Dakota County
CENTRAL GREENWAY
CONNECTIVITY
STUDY
October 31, 2017

Appendix: Public Comments

Central Greenway Connectivity Study
Project Area Existing Conditions

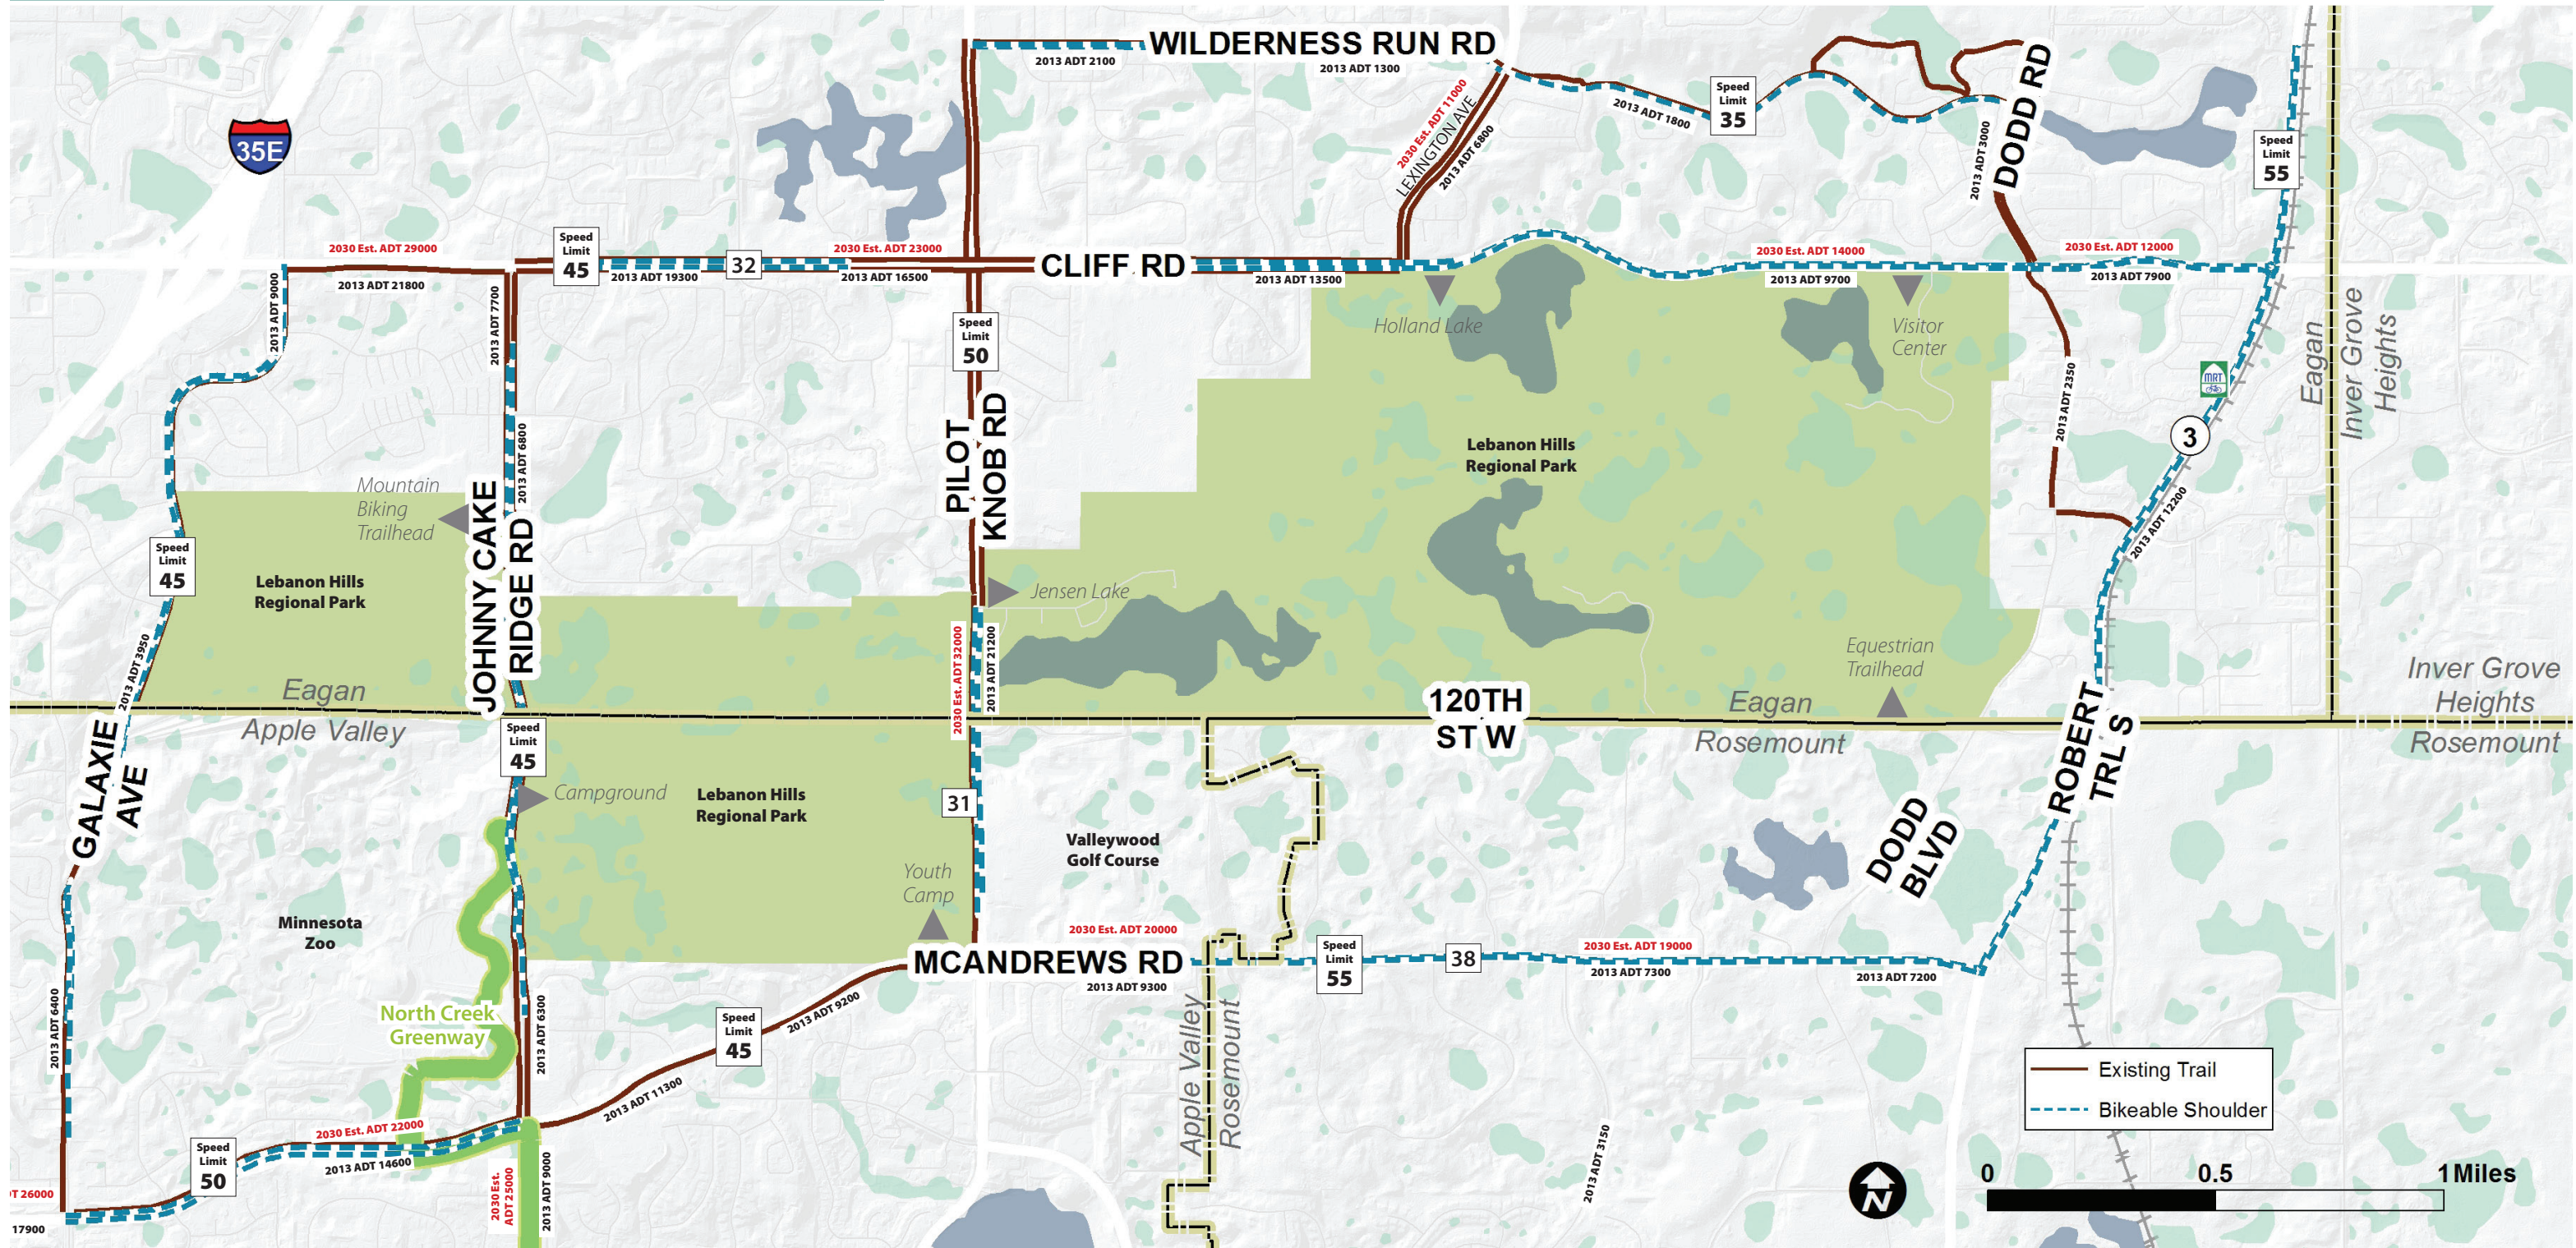
In 2015, the County Board approved a change to the Study which states the Connector trail within the park is not to serve as a segment of the greenway network. The images of the Connector Trail, however, were not removed from the maps in the Study.

The Central Greenway Study clearly shows the Connector Trail through Lebanon Hills as a segment of the Greenway network, which violates the Master Plan.

However, I would suggest in the graphics (as seen on p.6 for example) that you show the greenway not stopping at three entrances to Lebanon Hills Park but continuing on along those routes surrounding the park, incorporated possibly as shown on

Thank you for your comments, all comments will be included in the final study presented to the Dakota County Board of Commissioners. Just to clarify the Central Greenway Connectivity Study only proposes improving the on and off-road pedestrian system along existing roads around the park, the study does not make any recommendations about trails within Lebanon Hills Regional Park.
